14 CFR Part 39

[Docket No. 92-CE-63-AD]

Airworthiness Directives; Piper Aircraft Corporation PA-25 Series Airplanes

ACTION: Supplemental notice of proposed rulemaking (NPRM); Reopening of the comment period.

FIGURE 1

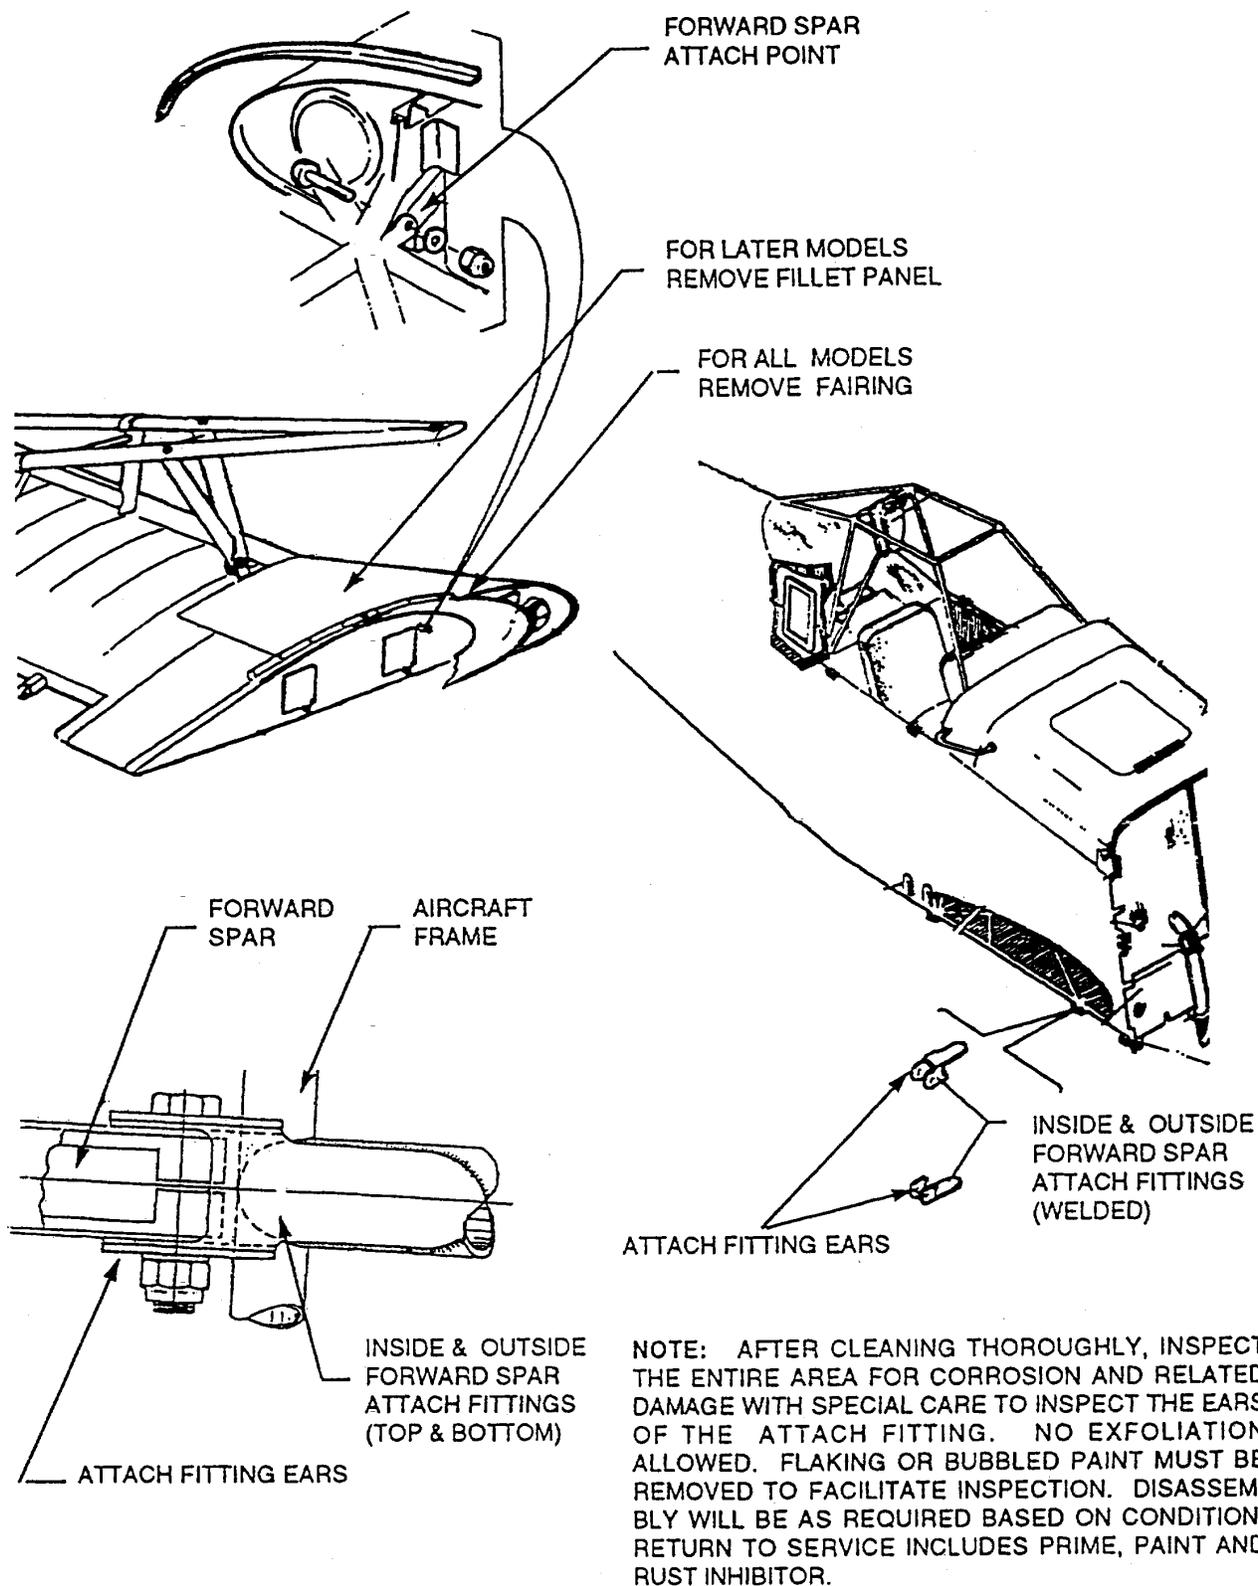
(a) Gain access to the left and right wing forward spar fuselage attach fittings by removing the screws retaining the wing fairing. Dismantle the wing fillet by removing the screws on the aft edge top and bottom and removing the wing fairing (see Figure 1 of the Appendix to this AD).

Figure 2

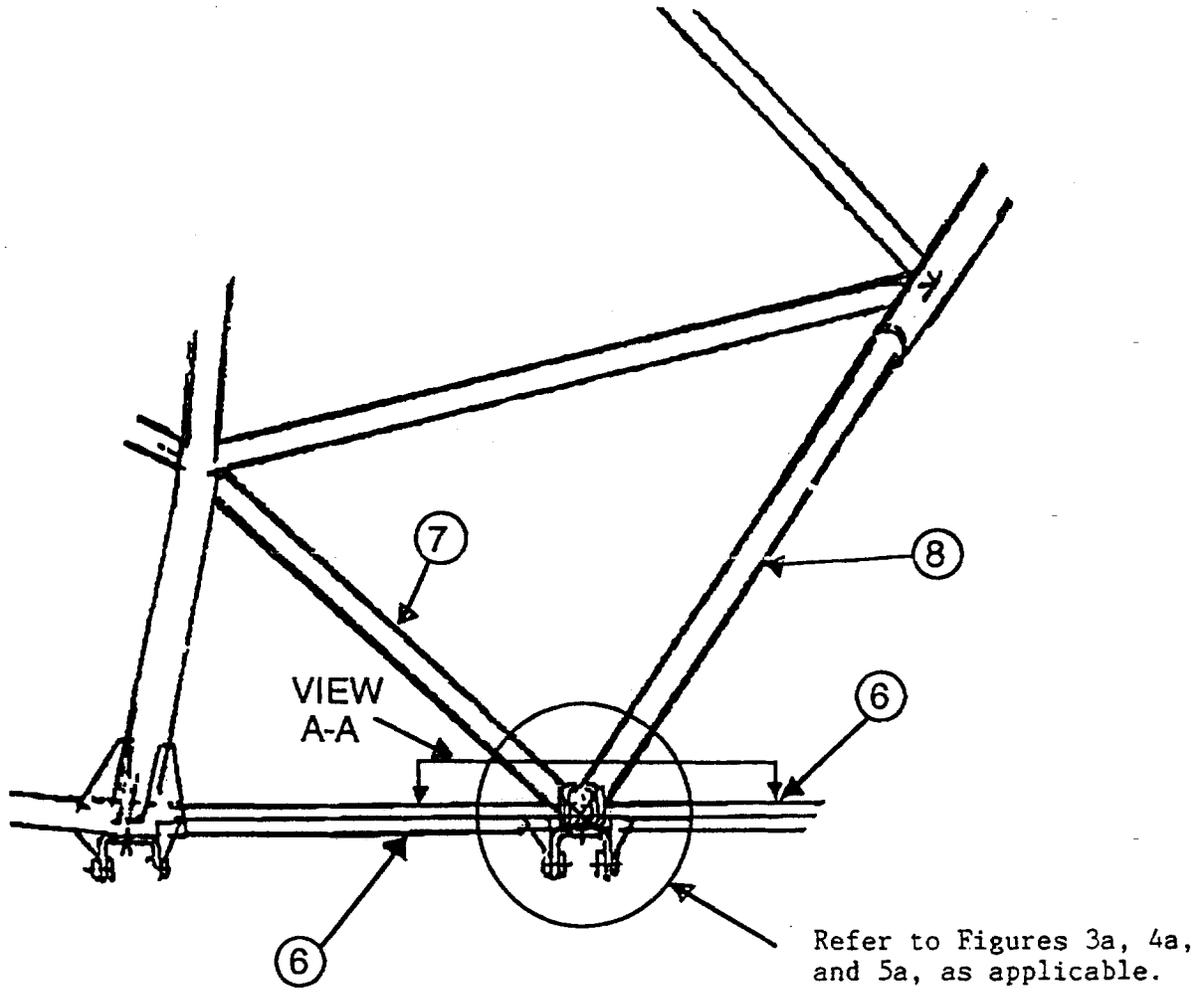
b. Cut the tubular members as referenced and specified in Figure 2 and either Figures 3a and 3b; Figures 4a and 4b; or Figures 5a and 5b, as applicable.

2. Cut the tubular members as referenced and specified in Figure 2 and either Figures 3a and 3b; Figures 4a and 4b; or Figures 5a and 5b, as applicable.

Figure 3a

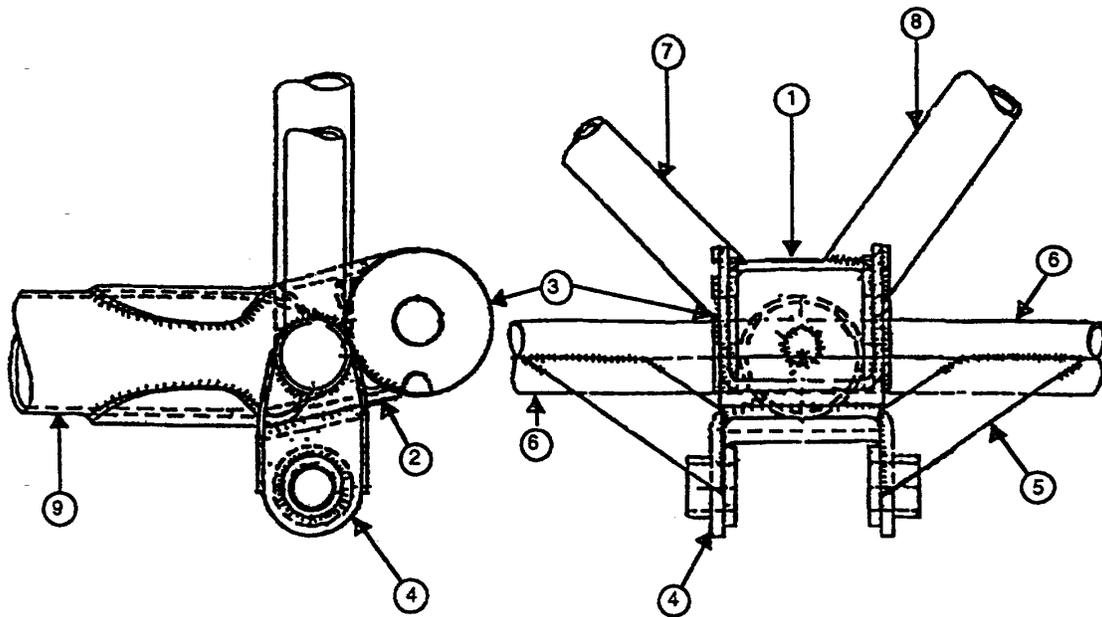
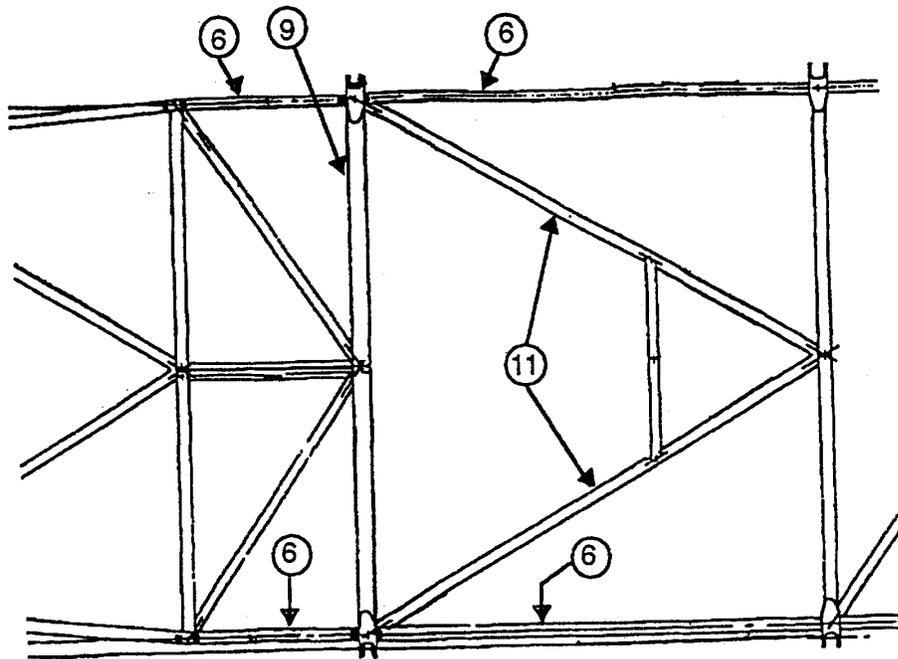
1. Add couplant to the outside inspection surface (Refer to Figures 3a,

2. Add couplant to the inside inspection surface (Refer to Figures 3a, 4a and 5a, as applicable). Add the appropriate gain to obtain the backwall echo from the inspection surface. To assure proper coupling to the test sample, twist the probe (clockwise and counter-clockwise with a 45-degree twist). During the articulation of the probe, observe the A-trace on the screen and stop the probe twist at the point of adequate back surface signal amplitude to trigger the thickness gate on the first half-cycle. Measure and record the thickness. Repeat the above process at eight equally-spaced locations around the surface.

3. If a thickness reading in any one of the eight locations from paragraph 1. of the *Inspection Procedures* section (outside section surface) is .085-inch or less for the PA25-150 Model or .055-inch or less for the PA25-235 and PA25-260 Models, or if a thickness reading in any one of the eight locations from paragraph 2. of the *Inspection Procedures* section (inside section surface) is .055-inch or less for the PA25-150 Model or .085-inch or less for the PA25-235 and PA25-260 Models, prior to further flight, replace the

c. Fabricate a cluster using all applicable part numbers referenced in Figures 3b, 4b, or 5b, as applicable; and
